Replies to comments on Mechanical GA of CW Pump house (Rev 01)

PROJECT	YADADRI THERMAL POWER STATION (5X800 MW)		
OWNER	TELENGANA STATE POWER GENERATION CORPORATION LIMITED		
OWNER'S CONSULTANT	TATA CONSULTING ENGINEERS LIMITED BANGALORE		
EPC CONTRACTOR	BHARAT HEAVY ELECTRICALS LIMITED, NEW DELHI UNIT : BOILER AUXILIARIES PLANT ; RANIPET PACKAGE : DM PLANT		
TITLE	EQUIPMENT LAYOUT OF DM PLANT		
DRAWN	BB SAHU	Sd/-	29.12.18
CHECKED	G RANENDRAN	Sd/-	29.12.18
APPROVED	M RAMAKRISHNA	Sd/-	29.12.18
ALL DIMENSIONS ARE IN MILLIMETRES	SHEL DRAWING NO.		
	1-WT-500-01296

TELANGANA POWER GENERATION CORPORATION LIMITED 5x800 MW YADADRI THERMAL POWER STATION Comments on BHEL Drawings / Document							
Drawing/Document Title: GA Drawing for Combined Fuel Oil Pump House (Unloading through road tanker cum Pressurising & Heating P/H)							
Comments on drawing/Document No.:PE-DG-417-166-A003 REV.02							
SL.NO.	TSGENCO/TCE Comment vide Transmittal no.: TCE.11005A-ME-VDT-375 dated 24.01.2020	BHEL REPLY	TSGENCO/TCE Comment vide Transmittal no.: 11005A-ME-VDT-435 dated 09.07.2020	BHEL REPLY	TSGENCO/TCE Comment vide Transmittal no.: TCE.11005A-ME-VDT-442 dt.23.07.2020	BHEL REPLY	Remarks
1	Indicate th

PRELIMINARY DRAWING FOR REFERENCE ONLY

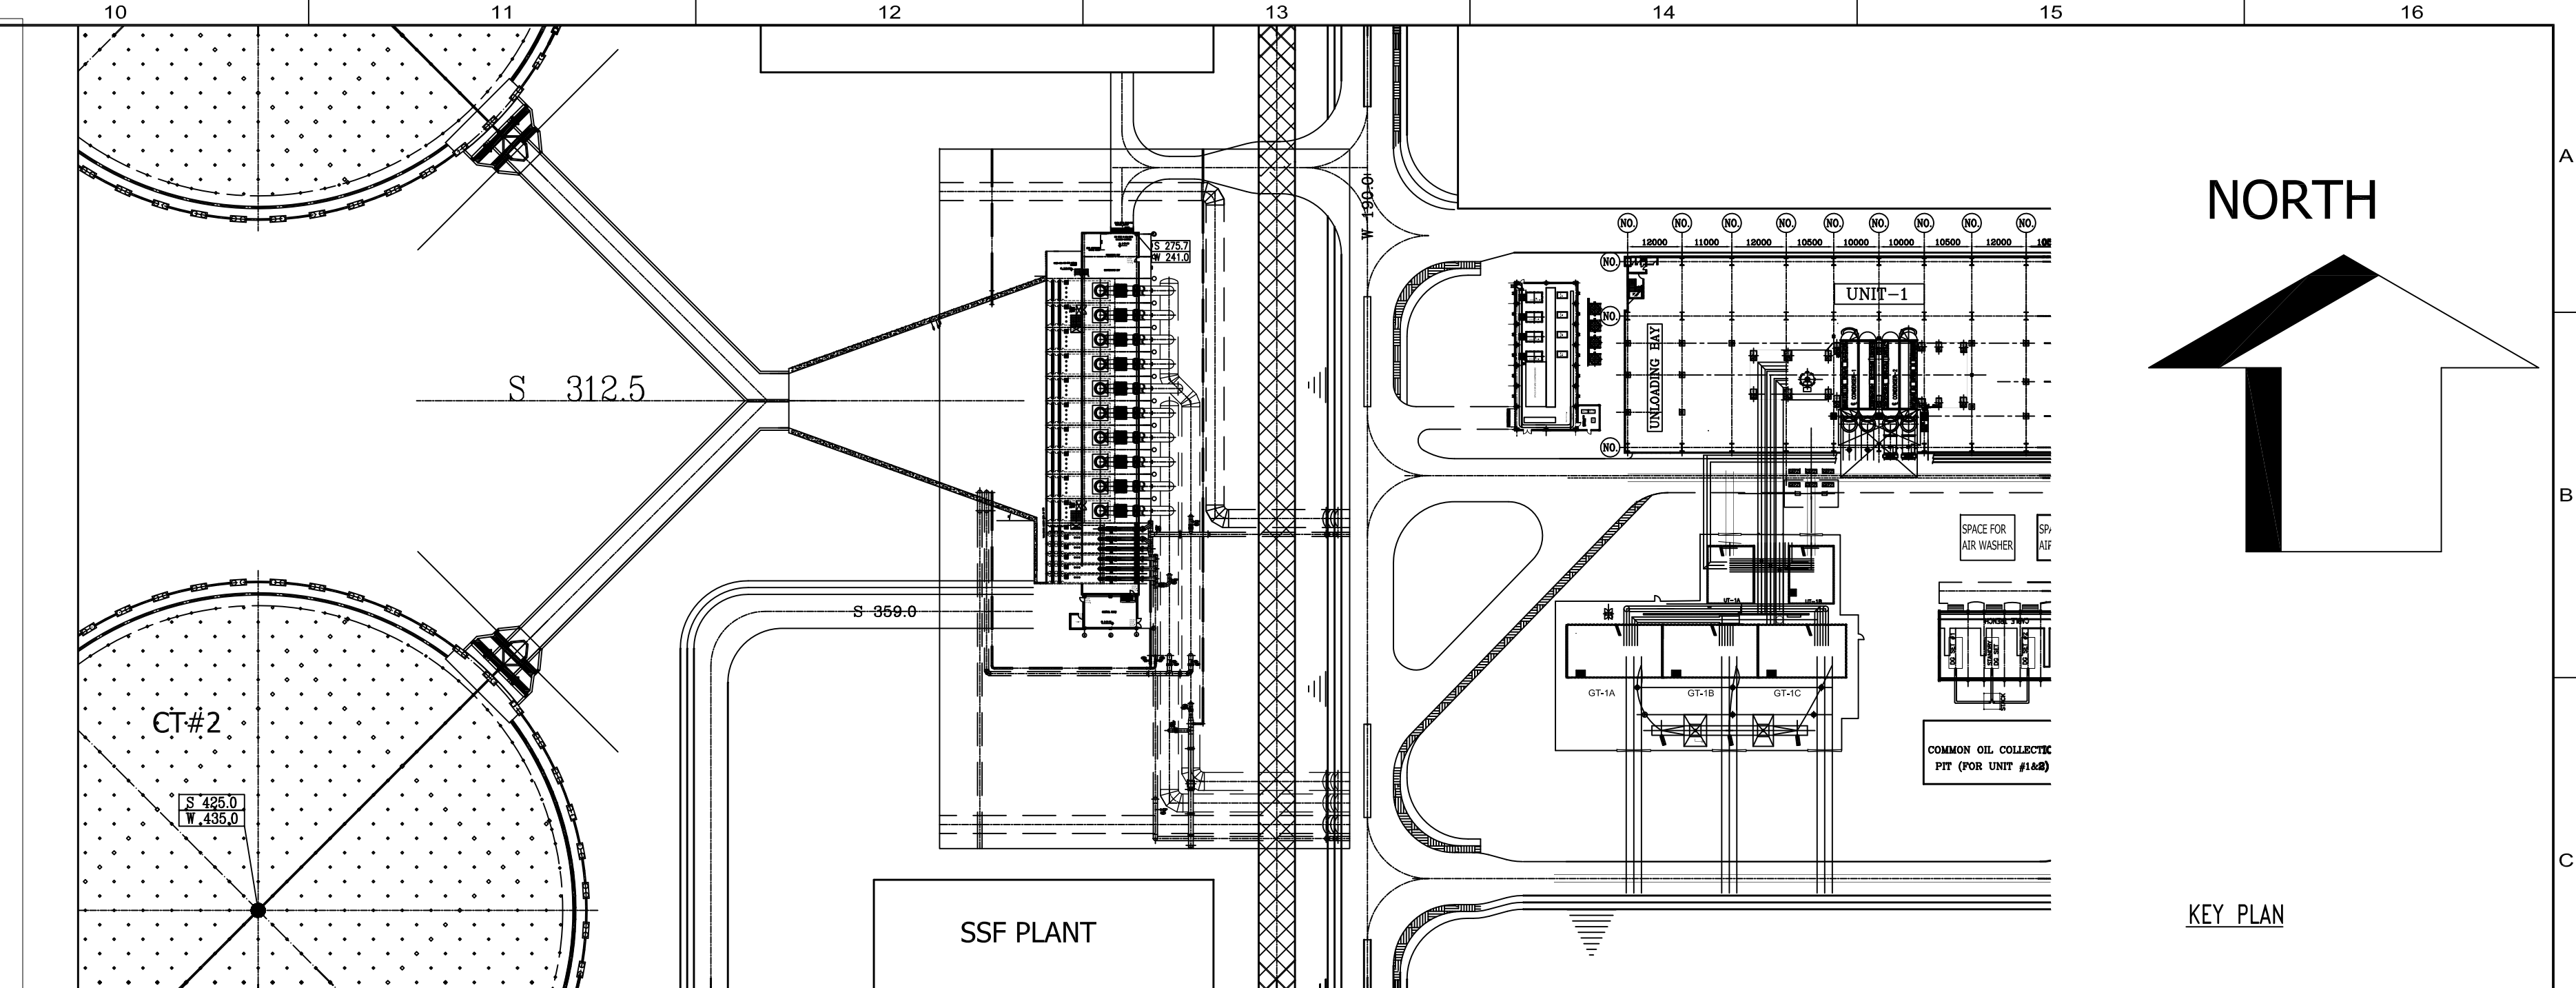
S. No	Customer Comments	BHEL Replies dated 24.12.2018
Comments marked on Word file		
1	Is there any storage rack considered for storing the stop logs.	Please note a Paved area near maintenance bay (500 mm above FGL) is provided for storage of stop log gate and stools are provided in this are for resting of stop log gate. There is no storage rack envisaged.
2	Indicate dimesion	Noted & incorporated.
3	Indicate the cross travell approach	Already provided in "CWP sectional View A-A"
4	56785?	checked & corrected.
5	3 No's LT shall be provided as per P & Id.	Noted & incorporated.
6	Provision shall be provided for Chlorine dosing along with other CW chemical dosing system.	Noted & Incorporated.
7	Please mark the dimension.	Noted & incorporated.
8	BHEL to explain where this kind of arrangement is made in earlier projects (except KTPS). BHEL to provide the reference for those projects (especially NTPC projects).	This arrangmenet is as per BHEL standard practice and already provided in number of projects viz. 2X660 MW RRUYNL Suratgarh TPS, 1X500 MW DVC Bokaro 'A' TPS, 1X700 MW KPCL Bellary TPS Unit-3 etc.. Further sump model study along wth CFD analysis shall be conducted for establishing the correctness of layout.

9	Does the arrangement is inline with HIS requirements?	
10	BHEL to confirm whether flow study & Modeling has been done to arrive the layout. If done and arrived the arrangement. BHEL to submit the same for reference	
11	Indicate electrical MCC roon	Please note there is no swichgear room in CWPH. Please refer PE-DG-417-505-A001.
12	FFL shall be marked.	Noted & incorporated.
13	CW pump and ACW pump foundation details shall be shown.	CW pump & ACW pump foundation details shall be provided in Civil GA of CW pump house.
14	BHEL to ensure the proper approach to the pumps	Noted.
15	Weight of Pump and motor shall be provided.	Weight of CW pump & motor shall be indicated in respective GA drawing (FP-1-182-005-7082 & BP-DG-417-207-001) submitted separately by BHEL-Hyderabad & Bhopal respectively.
16	Static load and dynamic load due to pump and motor set shall be furnished.	Static load and dynamic load due to pump and motor set shall be indicated in respective GA drawing (FP-1-182-005-7082 & BP-DG-417-207-001) submitted separately by BHEL-Hyderabad & Bhopal.

17	Pump data indicating the pump capacity, head, quantity shall be provided.	Noted & incorporated.
18	Indicate ventilation system requirement like fan and louver details shall be shown.	Ventilation system requirement shall be indicated in Architectural drawing of CW pump house (Drg no. PE-DG-417-653-C002, PE-DG-417-653-C003 & PE-DG-417-653-C004)
19	BHEL to indicate the holds as most of the equipments are to be order and are dependent on Vendor information. BHEL to indicate the same.	Noted.
21	Please mark water levels.	Water levels are already marked in CWP sectional view A-A. Further there is negligible pressure drop of 50 mm across screen and same can not be distinguished in water levels near screen in GA drawing.
22	Please indicate minimum submergence value.	Please note minimum water level in CW pump house is selected based on minimum submergence requirement and submergence requirement of 4950 mm is already indicated in the "CWP Sectional view A-A".

23	Dimension shall be provided.	Noted & incorporated.
24	Check the column grid locations and revise the dimension.	Noted & incorporated.
25	BHEL to indicate maintenance platform for motor	Maintenance platform for motor is envisaged in maintenance bay at EL (-) 1.0 M. However for local monitoring/inspection of motor, motor floor is already indicated at EL (+)5.65 M.
26	ARV shall be shown.	Noted & incorporated.
27	Dimension shall be provided.- CW Pump	Complete dimensions of CW pump shall be provided in CW pump GA drawing (drg no. FP-1-182-005-7082).
28	Please provide basis of crane selection (typical).	Required capacity of semi gantry crane is arrived as 5T, considering 10 % margin over heaviest equipment to be lifted i.e. stop log gate. Stop log gate is in two parts and weight of one part is approx. (1.8 ton+1 ton) including accessories of handling arrangement of gate. Thus selected capacity of semi gantry crane is in order.

29	EL shall be marked.	Noted & incorporated
30	Please mark the dimension.	Noted & incorporated
31	ARV shall be shown.	Noted & incorporated

HFO UNLOADING PUMP HOUSE – NEAR RAIL AREA

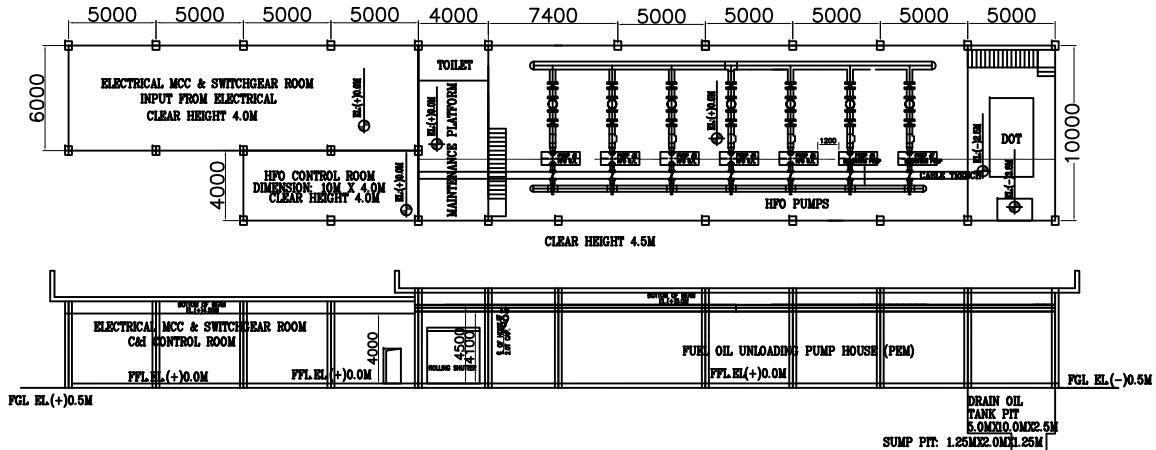
3	Cable tray shall be arranged in u shape as shown and panel shall be marked accordingly in u shape	Control panel arrangement is shown in the drawing. For further details with respect to cabling, kindly refer cable tray layout refer drawing no. PE-DG-417-100-E020 .	Noted. However, the cable tray is not extended upto control room. BHEL to check.	For cable tray layout refer drawing no. PE-DG-417-100-E020 . Comments has been taken care in electrical drawing.	Noted		
4	Indicate doors	Noted and incorporated.	Noted				
5	Mark the Glass partion between operator room and panel/DCS room	Noted and incorporated.	Noted				
6	Extend the cable tray as marked and locate the LVS, and operating pannel	Cabling layout covered in drawing no. PE-DG-417-100-E020 .	Noted.				
7	panel/DCS	Revised control & battery room has been indicated. For detailed layout refer drawing no.PE-DG-417-100-E020 .	Noted. However, the cable tray is not extended upto control room. BHEL to check.	For cable tray layout refer drawing no. PE-DG-417-100-E020 . Comments has been taken care in electrical drawing.	Noted

8	This portion shall be part of control room	Separate Battery Room has been provided. Please refer PE-DG-417-100-E020 for detailed layout.	Noted.				
9	operator room	Noted and incorporated. For detailed layout refer drawing no.PE-DG-417-100-E020 .	Noted.				
10	Indicate double here	Noted and incorporated. For detailed layout refer drawing no.PE-DG-417-100-E020.	Noted				
11	is it door?	Noted and correctly represented in the drawing.	Noted				
12	Indicate door Here	Noted and incorporated.	Noted				
13	Please mark the tentative LT MCC sizing as the load list is already finalised.Indicate cable tray details Pipe rack entry/exit details Indicate the details Exhaust fan, LDB, eye washer , fuse box etc Fire roof doors are to be shown LDB with lighting transformer.	For details, kindly refer Electrical Cabling layout in FO (P&H) area; Drawing no.PE-DG-417-100-E020. Ventilation fan openings has been shown in the drawing	Noted.

14	BHEL to indicate two LDO pumps and strainers refer HPVP P&ID (1-00-056-U8007)	The same is in line with approved documents (refer Drawing No.0-00-056-11165, Title:Foundation and TP details- Fuel oil pressurizing pump and heater sets). Confirmation mail from BHEL- HPVP regarding space provided for LDO pumps (HPVP scope) is attached.	Noted				
15	Please correct the text as LDO typical comment	Noted & corrected.	Noted				
16	Mono rail shall be upto maintainence area how to take the equipment till maintainence area if monorail is not avaiable	Maintenance area has been provided separately for Fuel oil pressurizing pump and heater sets (refer between grid no. 9 and 10 in this drawing)	Noted				
17	Correct the text as "Space for drain oil tank" Indicate the pump for drain oil tank (0-00-056-11169)	Noted & corrected.	Noted				
18	Indicate the strainers for these pumps also	Noted & incorporated	Noted

19	BHEL to indicate the piping inside the pump house for proper review of this drawing. BHEL to maintain adequate space for free man movement for accessing strainers , valve etc.	The pipe routing drawing is part of detail engineering drawings which is under preparation (Drg. number 0-42-120-02481) and the same shall be submitted to customer. However we confirm that adequate space will be envisaged for free man movement for accessing strainers, valves etc. which is a standard practise in all our boilers.	Noted				
20	Check the drafting error ,it is not clearly visible	Noted. The area has been indicated in dark. However, the details in this area of the pump house shall be in line with the approved documents (refer Drawing No.0-00-056-11165)	Noted				
21	Please check the coordinates are not matching with plot plan (M001)rev.3	checked & confirmed.	Noted				
22	Indicate the equipment details as shown in Raw water pump house	Noted & incorporated.	Noted

23	BHEL to furnish the small power distribution details drawing	Please refer drawing no.PE-DG-417-100-E020.	Noted.				
24	Indicate all other related drawings	Noted and incorporated.	Noted

25	BHEL to submit the drawing after finalisation of all details	Combined pump house drawing has been prepared for freezing building dimensions which is based on considering maximum size of equipments. Further, following points may be noted: i)The dimension of Pressurising & Heating pump house area is in line with approved document (refer Drawing No.0-00-056-11165, Title:Foundation and TP details- Fuel oil pressurizing pump and heater sets) ii) Electrical MCC and Control Room is in line with document (refer drawing no.PE-DG-417-100-E020) iii) Fuel oil unloading (road) pumps and strainer set, maximum dimension has been considered.	Noted.				
26			Indicate tool room	Noted & indicated tool room (refer grid 1a-1b)	Noted.		
27			Control room layout is not legible/ text is not clear typical comment/ Text is over lapping, please check typical comment	Noted & corrected.	Noted, however please refer the comment marked on the drawing	Noted. Comments indicated below at Sl.No.29, 30 & 31

28			Width of the rolling shutter shall be 4.5m (minimum) and shutter shall be motor operated	Noted & incorporated.	Noted		
29					Distance between the panels shall be 1100mm as in CCR, same philosophy shall be followed for all control rooms	Noted & incorporated	
30					BHEL to indicate the approach to the pit and give details for sump pump etc in separate section veiw	i)For approach to the pit, please refer drawing (Drawing no.PE-DG-417-634-C022,Title:FUEL OIL PUMP HOUSE- GA AND RC DETAILS OF GRADE SLAB) ii)For detailsof sump pump etc in separate section view, please refer details N of drawing (Drawing no.0-00-056-11165, Title: FOUNDATION & TP DETAILS- FOPPH & HEATER SET)	
31					show the approach road	Noted & incorporated
